Access Compliance Report

Public Rights-of-Way

Intersection ID: 2905	Main Street: RIDGE_RD	Cross Street: SHELLEY_AV	Location: SW
ADA ID: 364D36D69FCE	Ramp Type: BlendTrans1	Initial Pass/Fail: Fail	Overall Compliance: No
Codes/Mitigation Info/Possible Solution		Field Measurements/Component Compliance	
Severity Score: 8.75

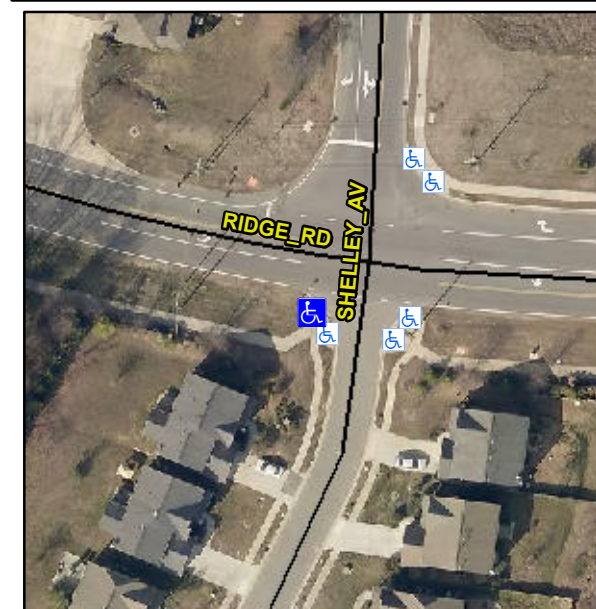
CURB LIP 0.5

Not Found, R304.5.1

Compliance	Description	Data	Compliance	Description	Data
N/A	Ramp Length (in)	132.0	Yes	BlendTrans Slope (%)	4.5
No	Ramp Width (in)	45.0	Yes	BlendTrans XSlope (%)	0.2
N/A	Flare Type LT	N/A	N/A	Flare Type RT	N/A
N/A	Flare Slope LT (%)	N/A	N/A	Flare Slope RT (%)	N/A
N/A	Flare Traversable LT?	N/A	N/A	Flare Traversable RT?	N/A
N/A	Landing Length (in)	N/A	N/A	DWS Provided?	N/A
N/A	Landing Width (in)	N/A	N/A	DWS Contrast?	N/A
N/A	Landing Slope (%)	N/A	N/A	DWS Length (in)	N/A
N/A	Landing X Slope (%)	N/A	N/A	DWS Full Width?	N/A
N/A	Landing Curb? (Y/N)	N/A	N/A	DWS Offset (in)	N/A
N/A	Shared Landing?	N/A			
N/A	Gutter Ponding?	N/A	N/A	Gutter Slope (%)	N/A
N/A	Gutter Lip Ht (in)	N/A	N/A	Gutter X Slope (%)	N/A
N/A	Painted X Walk1?	No	N/A	Painted X Walk2?	N/A
	X Walk 1 Direction	To N		X Walk 2 Direction	N/A
	X Walk 1 Width (in)	N/A		X Walk 2 Width (in)	N/A
	X Walk 1 Slope (%)	4.5		X Walk 2 Slope (%)	N/A
	X Walk 1 X Slope (%)	2.8		X Walk 2 X Slope (%)	N/A

N/A	Ramp inside XWalk1?	N/A	N/A	Ramp inside XWalk2?	N/A
	Road Slope (%)	2.8		Clear Space?	N/A
	Road X Slope (%)	4.5	N/A	Clear Space to XWalk (in)	N/A
N/A	Any Obstructions?	N/A	N/A	Storm Grate/Utility Hazard?	N/A
	Obstruction Type			Storm Grate/Utility Type	
		N/A			N/A
			Yes	Surface Condition? (G/P)	Good
			No	Curb Slope (%)	22.2

Remove & Replace Curb Ramp With Two New Directional Ramps or Equivalent.
